Comparison Document CSC5/S1NMA vs CSC6/S1NMA2

140-146 Camden Street London, NW1 9PF

14th May 2019

CSC6/S1NMA2 Proposed Lower Ground Floor Plan

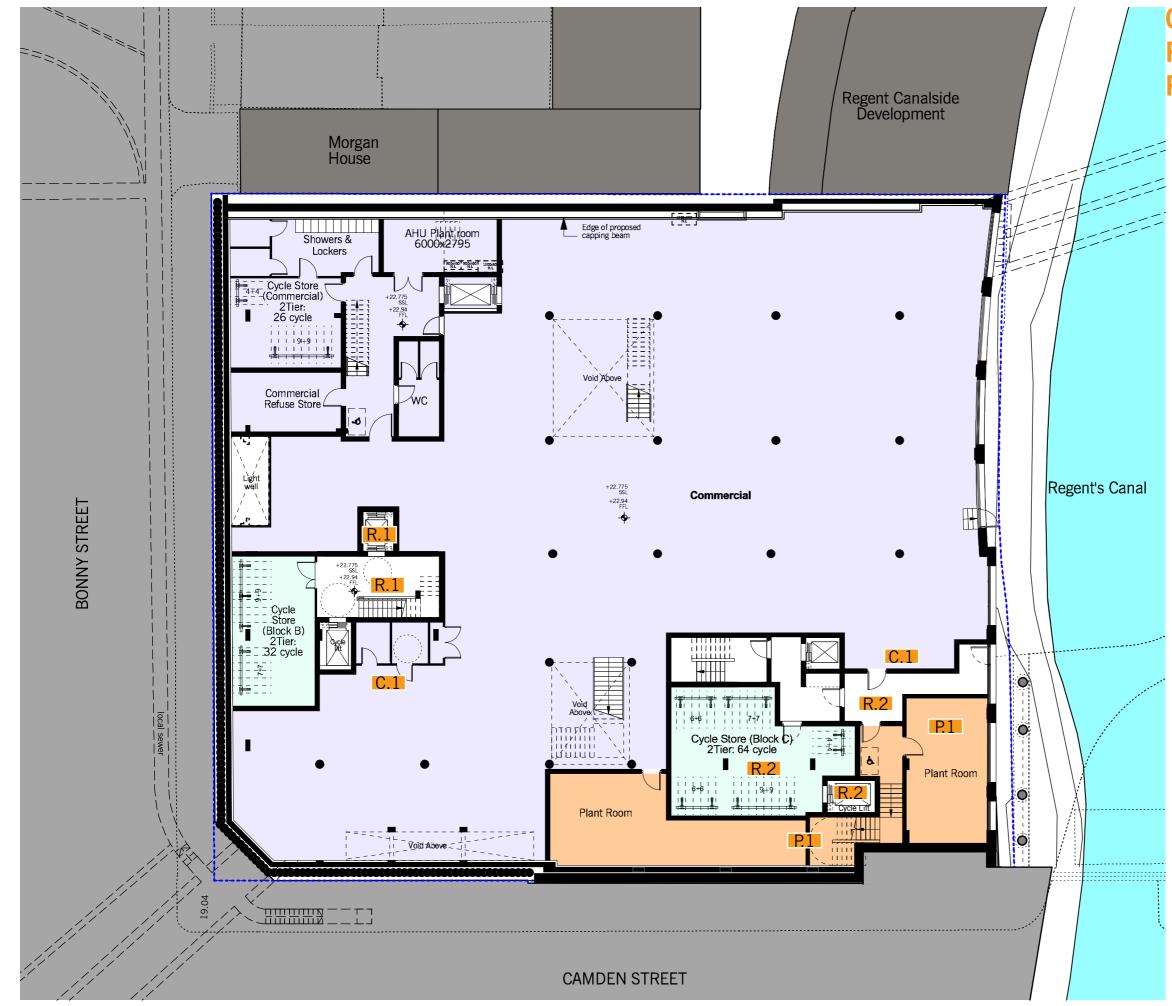
R.1) Core B lift and staircase repositioned, Core of Block A and B combined.R.2) Block C cycle store revised, cycle lift repositioned, staircases amended.

C.1) General revisions to accord with the amendments to the residential area.

P.1) Plant room revised, substation relocated to ground level.

CSC6/S1NMA2 Proposed Ground Floor Plan

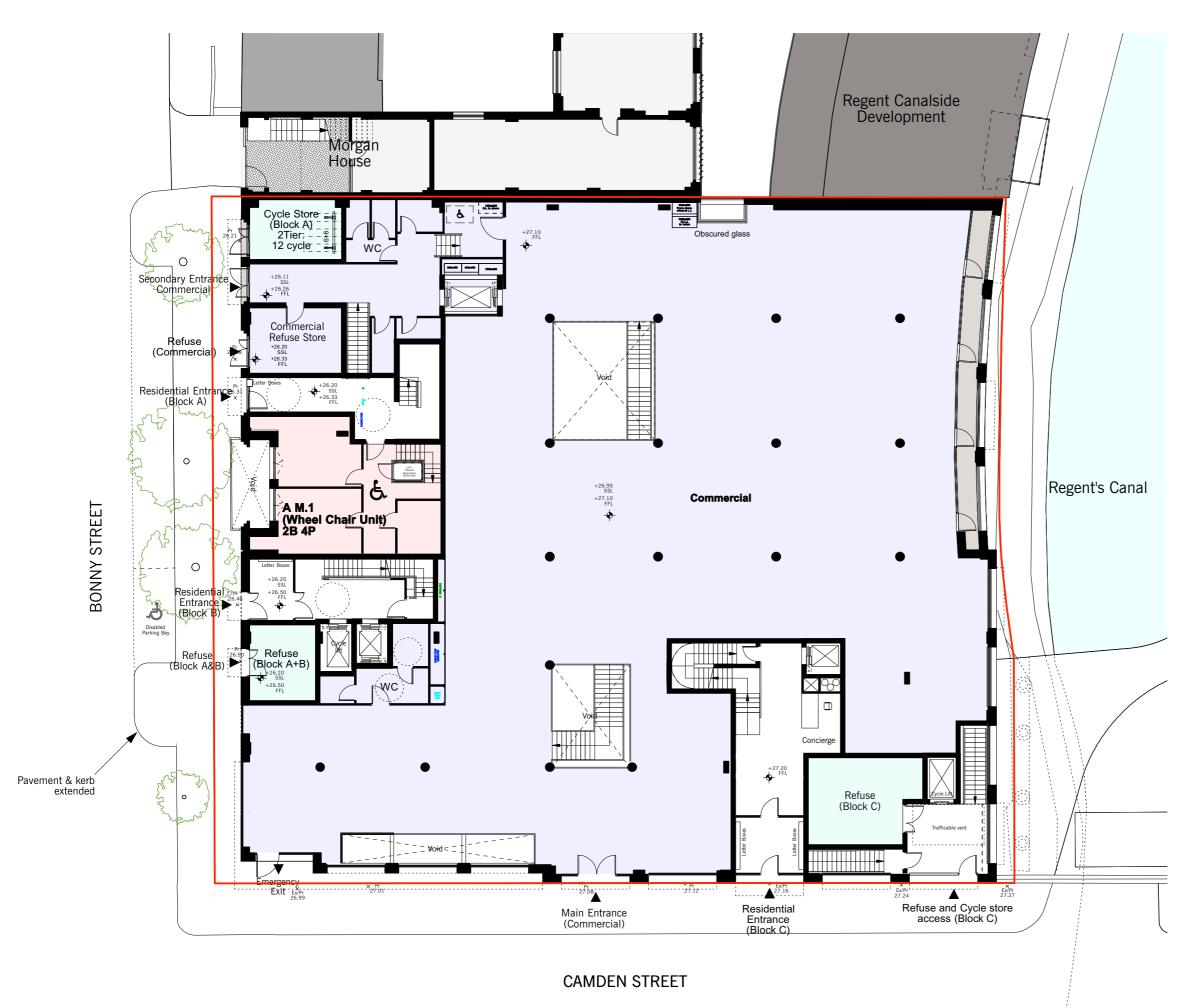
R.1) Core B lift and staircase repositioned, Core of Block A and B combined.

R.3) Block A&B entrance combined.

R.4) Arrangement of wheelchair unit revised with living area at ground floor and bedrooms at the first floor to accord with repositioning of the lift.

R.5) Block C refuse store and cycle lift repositioned, staircases amended, door added.

C.1) General revisions to accord with the amendments to the residential area.

S.1) Substation relocated to ground level.

CSC6/S1NMA2 Proposed First Floor Plan

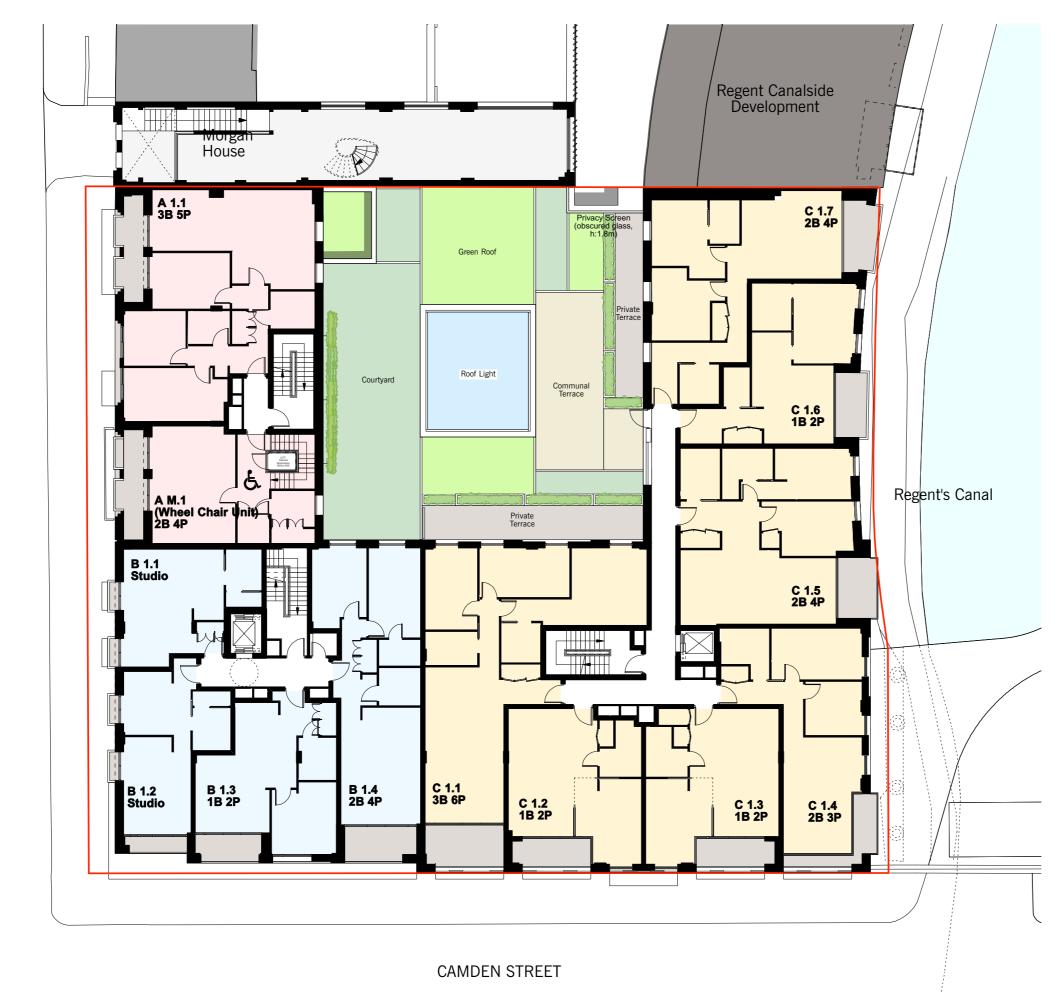
R.1) Core B lift and staircase repositioned,
Core of Block A and B combined.
R.4) Arrangement of wheelchair unit revised with living area at ground floor and bedrooms at the first floor to accord with repositioning of the lift.
R.6) General amendments to the internal layout in Block A&B to suit the amendments to the cores.
R.7) Lightwell to rear of Flat A1.1 enlarged
R.8) Private terraces on the roof above ground floor commercial area omitted.
R.9) Services risers indicated.

C.2) Rooflight design revised.

C.3) Roof above ground floor commercial area revised.

CSC6/S1NMA2 Proposed Second Floor Plan

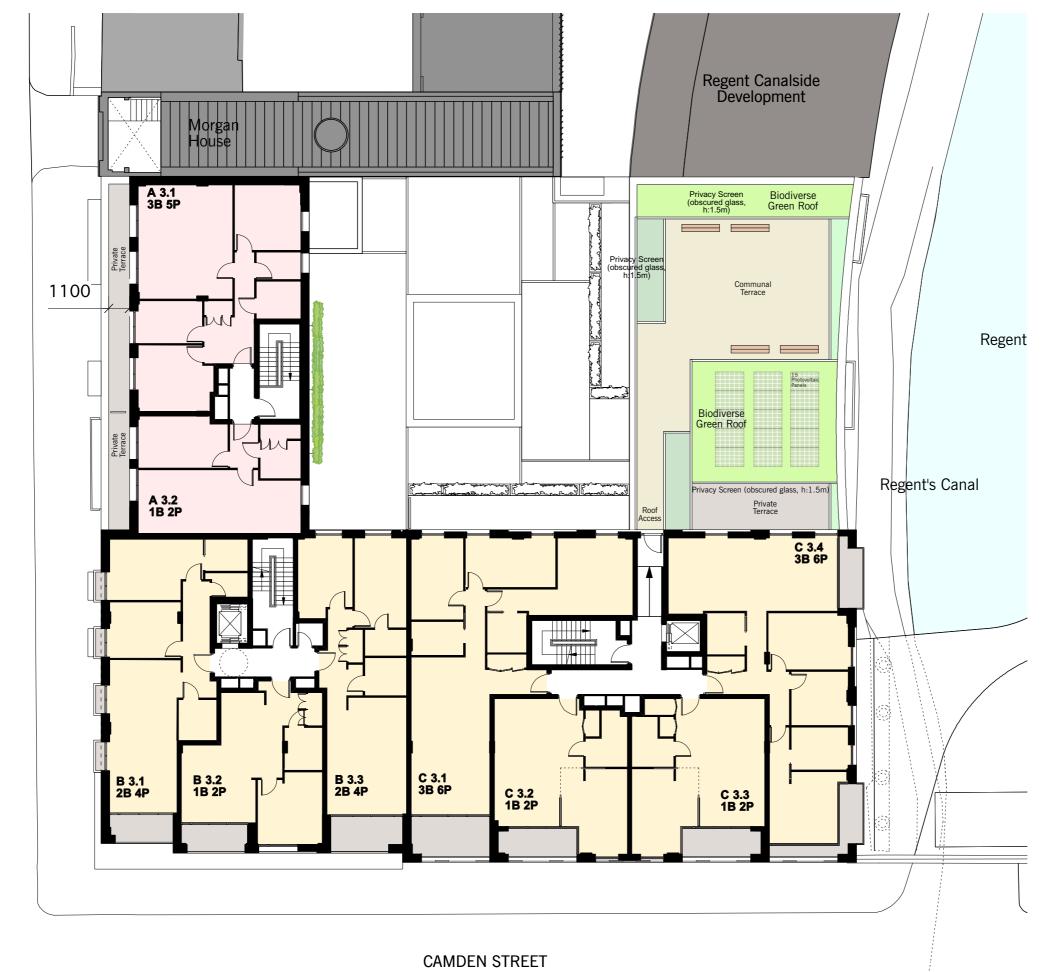
R.1) Core B lift and staircase repositioned,Core of Block A and B combined.R.6) General amendments to the internal layout inBlock A&B to suit the amendments to the cores.R.9) Services risers indicated.

CSC6/S1NMA2 **Proposed Third Floor Plan**

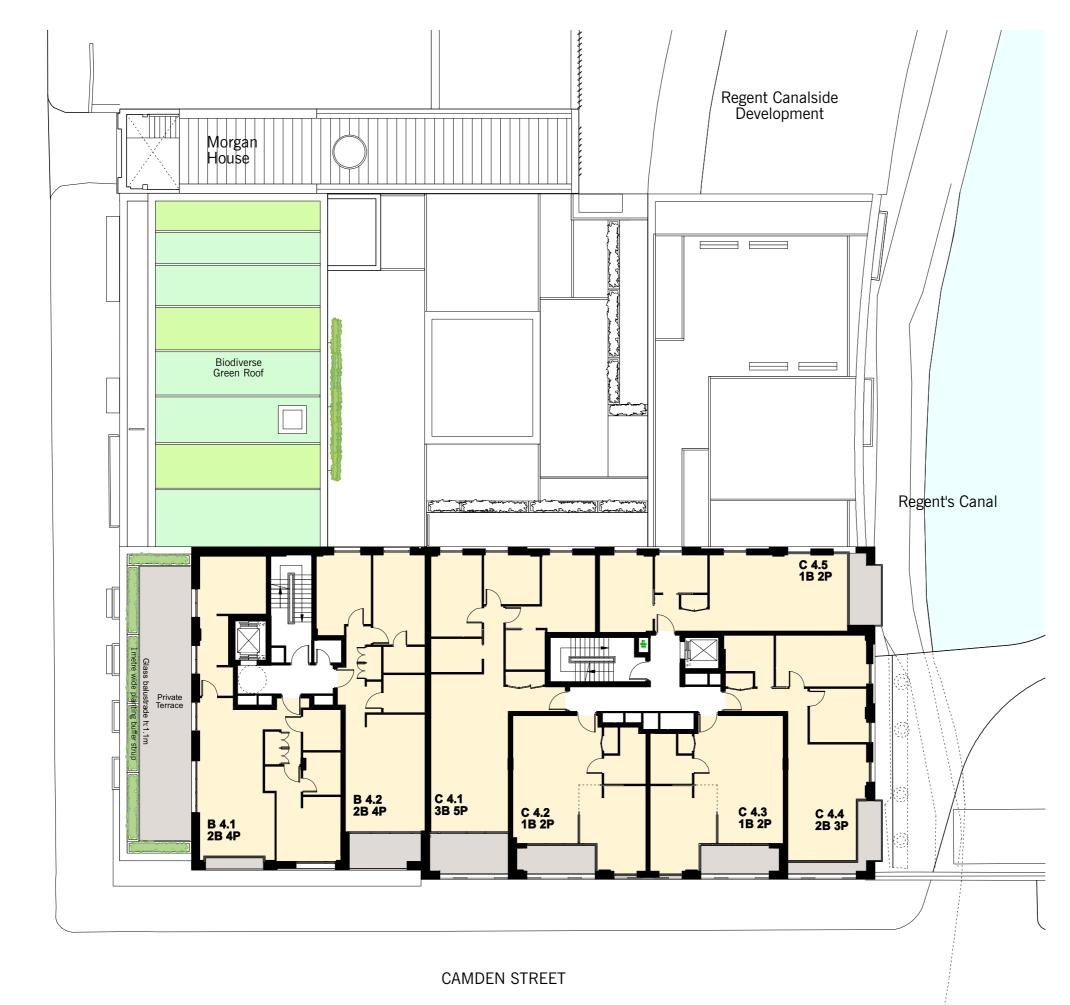
R.1) Core B lift and staircase repositioned, Core of Block A and B combined. R.6) General amendments to the internal layout in Block A&B to suit the amendments to the cores. R.9) Services risers indicated.
